# UNITED STATES PATENT AND TRADEMARK OFFICE

APPLICATION NO.	FILING DATE	FIRST NAMED INVENTOR	ATTORNEY DOCKET NO.	CONFIRMATION NO.
09/493,692	01/28/2000	Bahram Javidi	98-2091	2545
23413	7590	07/18/2005	EXAMINER	
CANTOR COLBURN, LLP 55 GRIFFIN ROAD SOUTH BLOOMFIELD, CT 06002			LAVARIAS, ARNEL C	
			ART UNIT	PAPER NUMBER
			2872

<b>Office Action Summary</b>	<b>Application No.</b>	<b>Applicant(s)</b>	
	09/493,692	JAVIDI, BAHRAM	
	<b>Examiner</b>	<b>Art Unit</b>	
	Arnel C. Lavarias	2872

## DETAILED ACTION

FIG. 12A

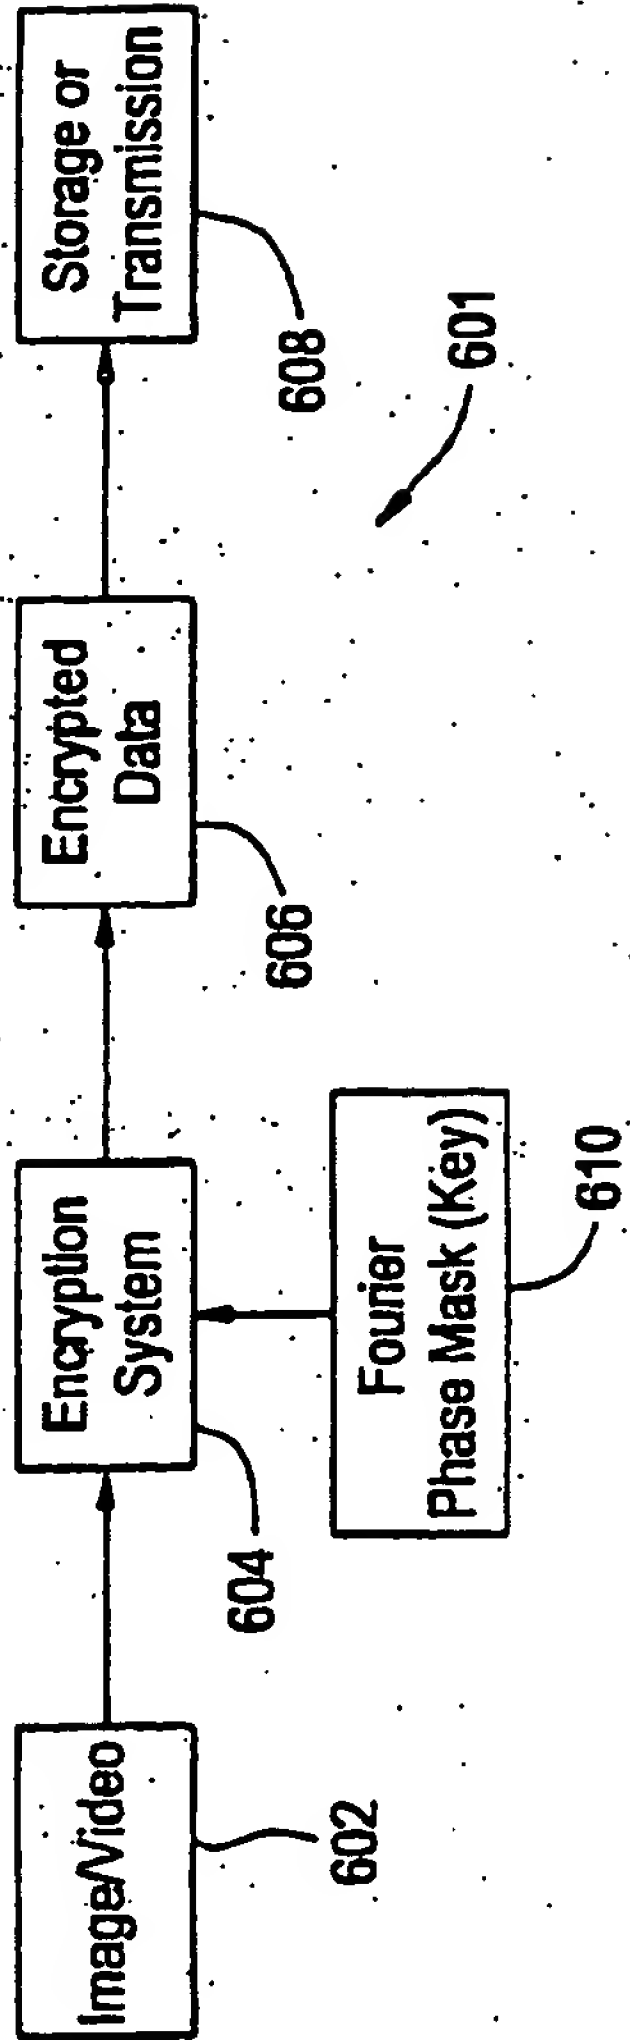
2. The drawings are objected to as failing to comply with 37 CFR 1.84(p)(5) because they include the following reference character(s) not mentioned in the description:

Figure 12A- Reference numeral 601

Corrected drawing sheets in compliance with 37 CFR 1.121(d), or amendment to the specification to add the reference character(s) in the description in compliance with 37 CFR 1.121(b) are required in reply to the Office action to avoid abandonment of the application. Any amended replacement drawing sheet should include all of the figures appearing on the immediate prior version of the sheet, even if only one figure is being amended. Each drawing sheet submitted after the filing date of an application must be labeled in the top margin as either "Replacement Sheet" or "New Sheet" pursuant to 37 CFR 1.121(d). If the changes are not accepted by the examiner, the applicant will be notified and informed of any required corrective action in the next Office action. The objection to the drawings will not be held in abeyance.

FIG. 12B

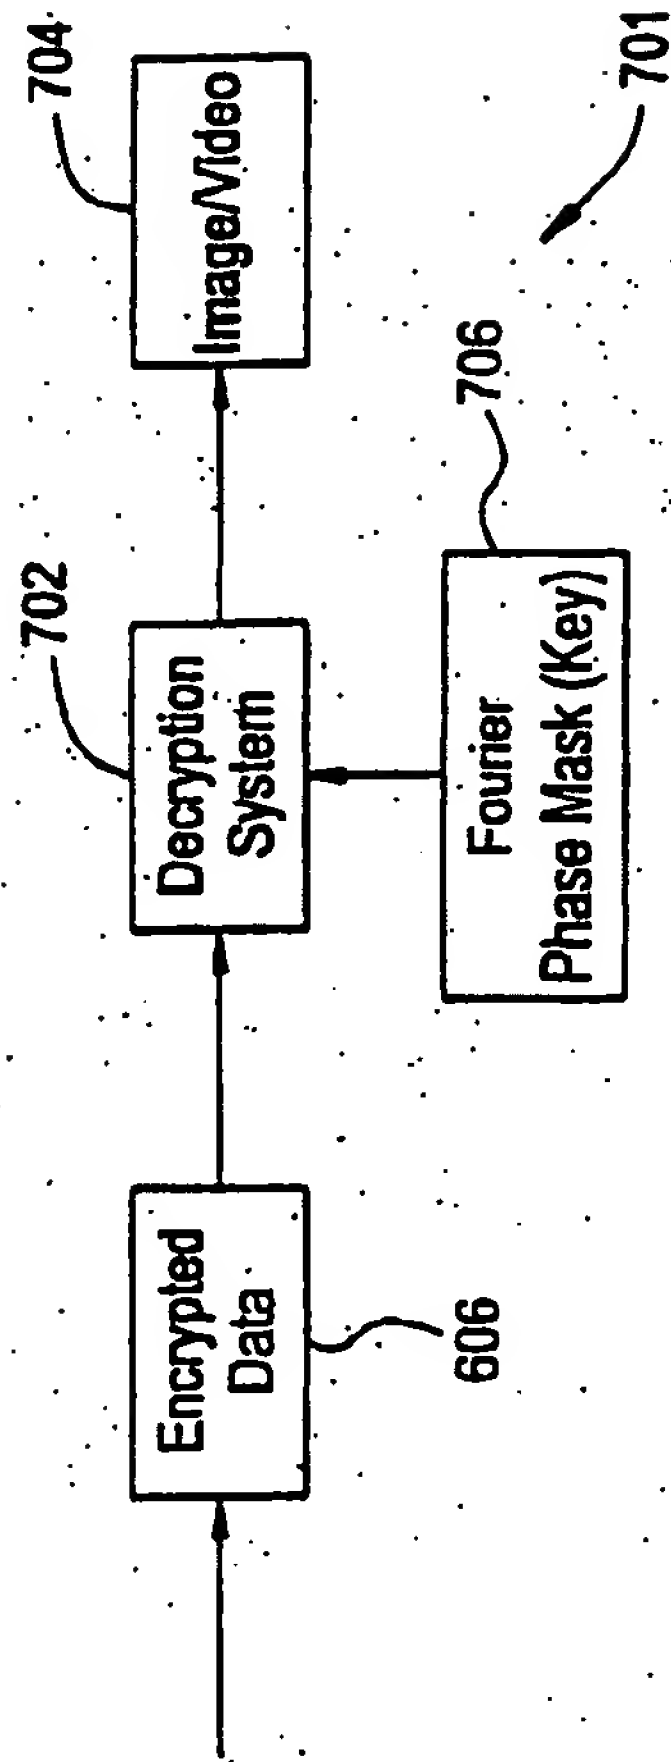
Figure 12B- Reference numeral 701.
